STATE OF VERMONT AGENCY OF TRANSPORTATION

PROPOSED IMPROVEMENT SAFETY PROJECT TOWN OF SPRINGFIELD COUNTY OF WINDSOR

PROJECT DESCRIPTION: PARTICIPATION: REPAIR AND REHABILITATION OF EXISTING METAL BINWALL ALONG LEFT SIDE OF TH 1, INSTALLATION OF NEW DRAINAGE AND SIDEWALK ALONG LEFT SIDE OF TH 325, COLD PLANING AND PLACING NEW BITUMINOUS CONC. PAVEMENT ON TH 325 .

RECORD PLANS

**DRAINAGE & UTILITIES
LAYOUT SHEET (1)**

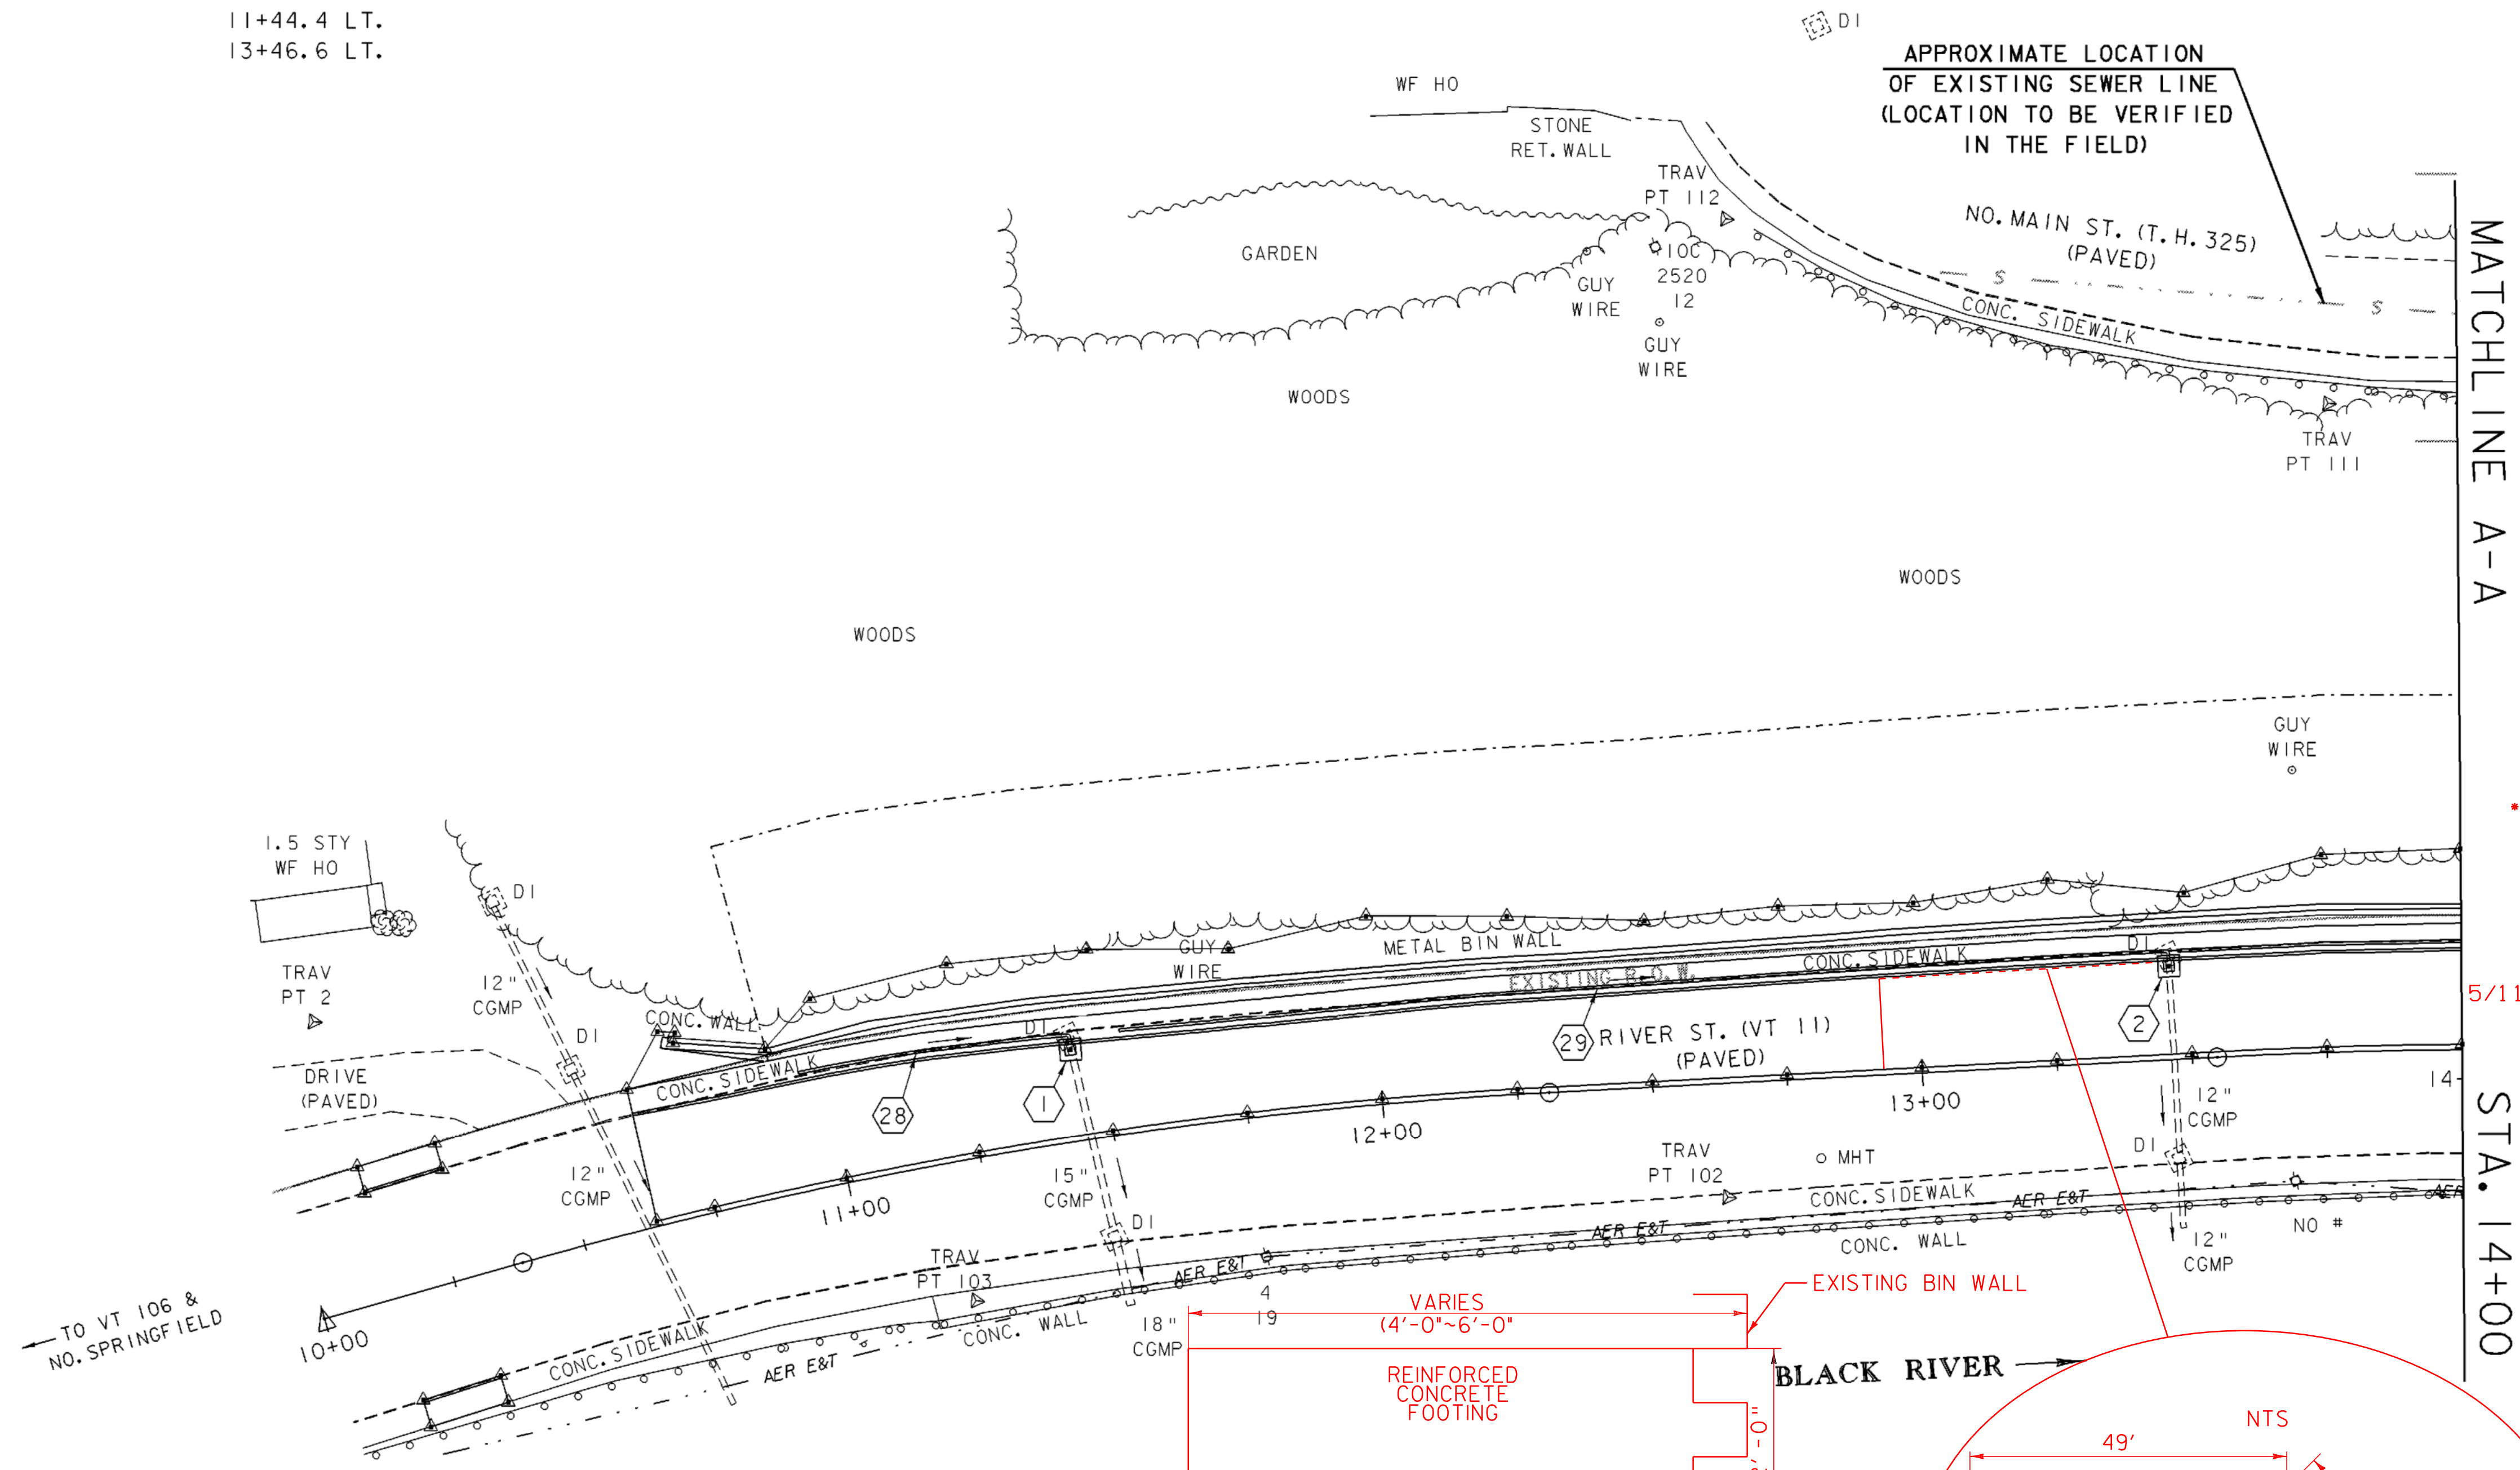
CB #2 - REMOVED EXISTING CB 4/28/05
- OLD BASE SITTING ON LEDGE
- 15' CMP 100% FULL OF DEBRIS

EXISTING CULVERT CROSSING PIPES @ CB #1-3
CLEANED BY JETTING/VAC. TRUCK ON 4/29/05
CHANGE ORDER TO FOLLOW

DRAINAGE PROFILE ACROSS VT. 11 (RIVER ST.)

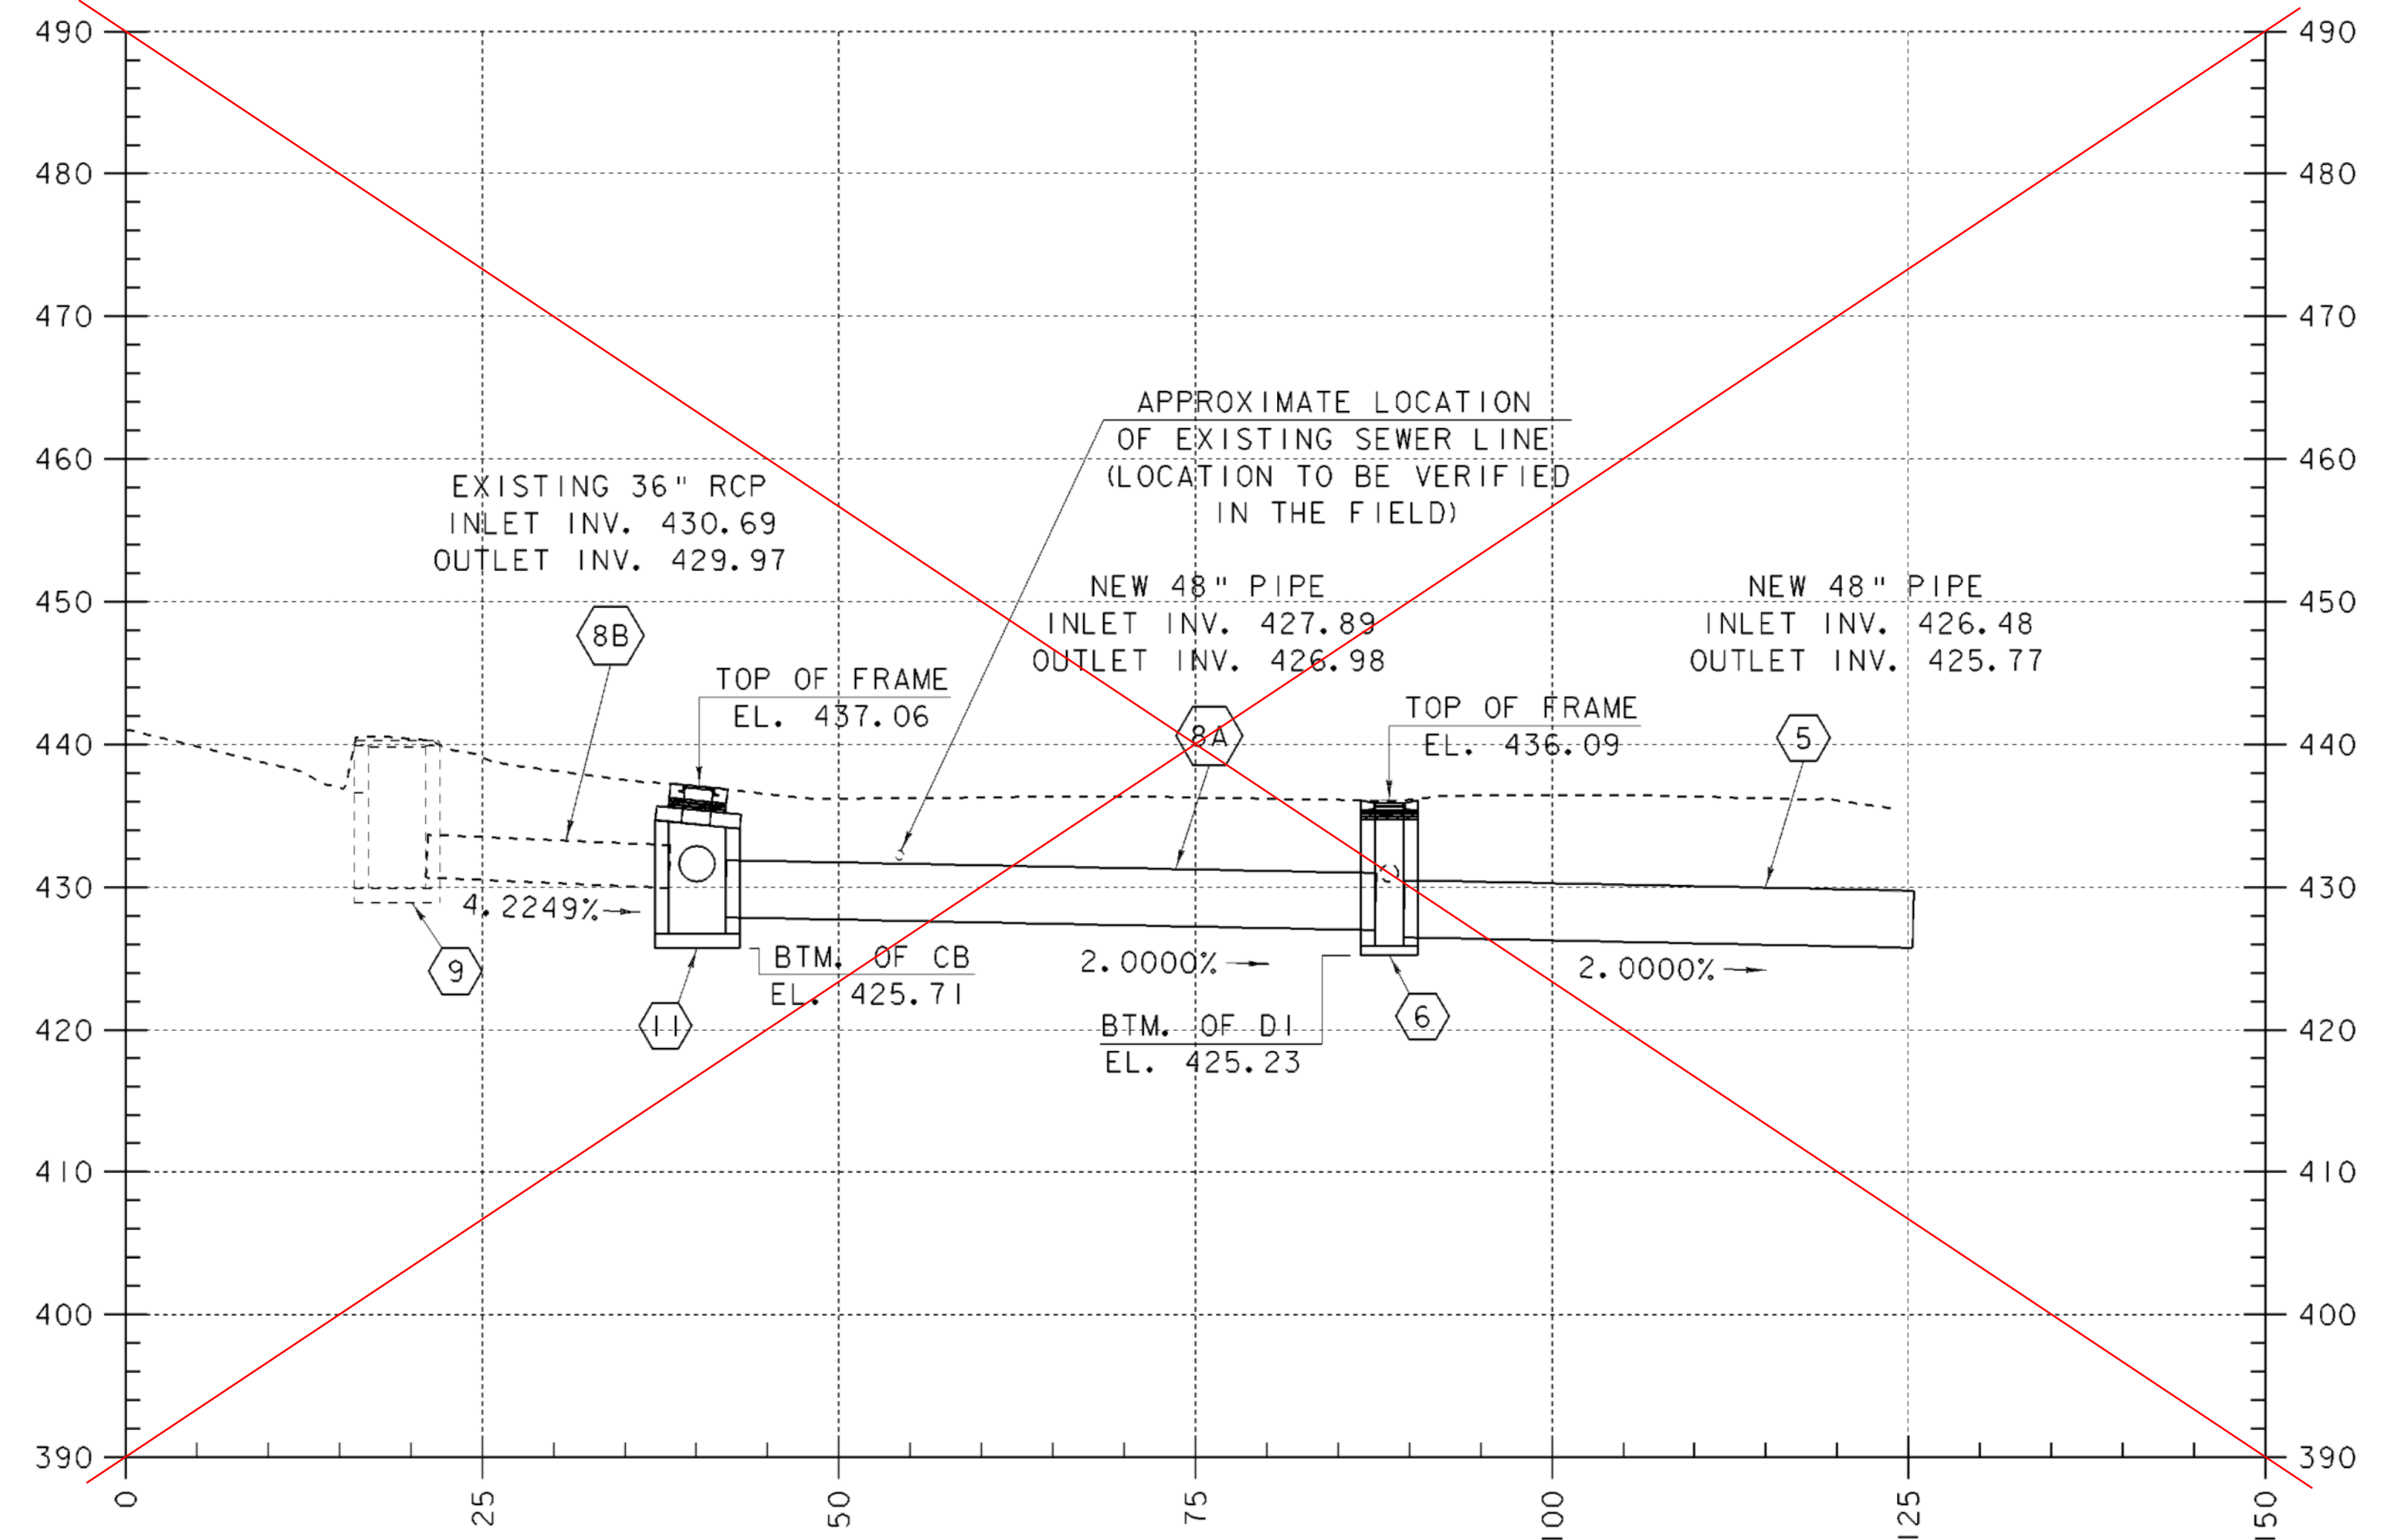
- NEW 48" Ø RCP NOT INSTALLED AS DIRECTED BY TOWN OF SPRINGFIELD DPW DUE TO POTENTIAL CONFLICTS WITH 12" SANITARY FORCE MAIN LOCATED ADJACENT TO EXISTING CONCRETE SIDEWALK ON SOUTH SIDE OF RIVER RD (RTE 11).
- SEE SKETCH ON 5/9/05 DWR - TEST HOLE DATA.
- SEE LETTER DATED 5/10/05, FROM ROBERT FORQUITES (TOWN MANAGER) DIRECTING VAOT TO LEAVE THE EXISTING 36" Ø RCP IN-PLACE.
